**Meeting Minutes Transmittal/Approval
Project Managers' Meeting
200 Area Groundwater and Source Operable Units
1200 Jadwin, Richland, Washington
June 19, 2008**

200 AREA PROJECT MANAGERS' MEETING AGENDA

Location Plat for New Wells Near LERF in 200-E

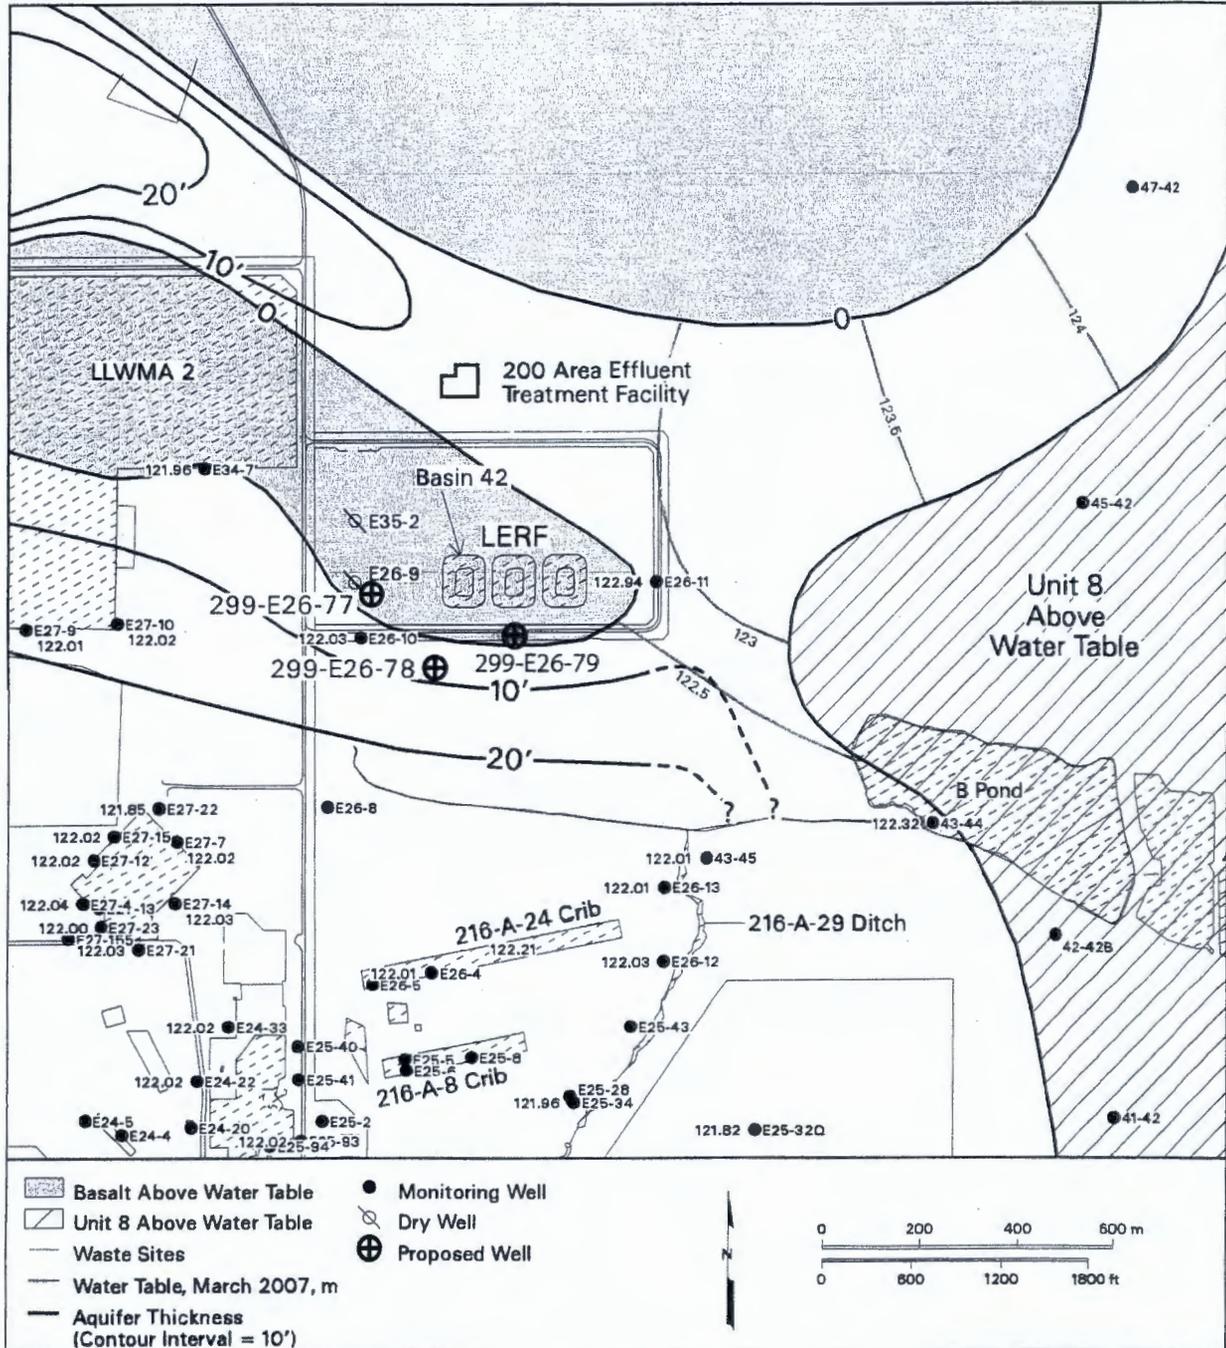
Agreement: TPA-CN-206 for DOE/RL-2003-30, Rev. 3, Waste Control Plan for the 200-BP-5 Operable Unit: Add two monitoring wells and an alternate monitoring well at the Liquid Effluent Retention Facility (LERF). Add one replacement well at Waste Management Area B-BX-BY (WMA B-BX-BY) (**Attachment 17**).

Justification and Impacts of Change:			
<p>Two monitoring wells are to be installed at the LERF because the water table has declined causing existing wells to go dry. An alternate well location is provided as a contingency. The well at WMA B-BX-BY is drilled adjacent to the initial well (299-E33-344) which was completed at a depth within a perching interval in the vadose zone instead of in the unconfined aquifer as planned. These changes will be reflected in the next revision to the 200-BP-5 Waste Control Plan.</p>			
Approvals:			
 RL Project Manager	6/16/08 Date	<input checked="" type="checkbox"/> Approved	<input type="checkbox"/> Disapproved
 EPA Project Manager (BP-5 OU Lead)	6/16/08 Date	<input checked="" type="checkbox"/> Approved	<input type="checkbox"/> Disapproved

Change Number TPA-CN-206	Document Submitted Under Tri-Party Agreement Milestone N/A	Date: 06/___/08	
Document Number and Title: DOE/RL-2003-30, Revision 3, <i>Waste Control Plan for the 200-BP-5 Operable Unit</i>		Date Document Last Issued: October 2007	
Originator: Greg S. Thomas		Phone: 373-3907	
Description of Change: Add two monitoring wells and an alternate monitoring well at the Liquid Effluent Retention Facility (LERF). Add one replacement well at Waste Management Area B-BX-BY (WMA B-BX-BY).			
<p><u>B. Charboneau</u> and <u>R. Lobos</u> agree that the proposed change modifies an approved RL Lead Regulatory Agency workplan/document and will be processed in accordance with the Tri-Party Agreement Action Plan, Section 9.0, <i>Documentation and Records</i>, and not Chapter 12.0, <i>Changes to the Agreement</i>.</p> <p>Attachment 1 of the above referenced plan has been modified to add two monitoring wells (299-E26-77 & 299-E26-78) and an alternate monitoring well (299-E26-79) at the LERF and also to add one replacement well (299-E33-345) at WMA B-BX-BY.</p> <p>A location plat is provided for the LERF wells. Revised well lists (Table 1, page 13, and Table 2, page 15, of Attachment 1) are also provided with the changes identified in shaded text.</p>
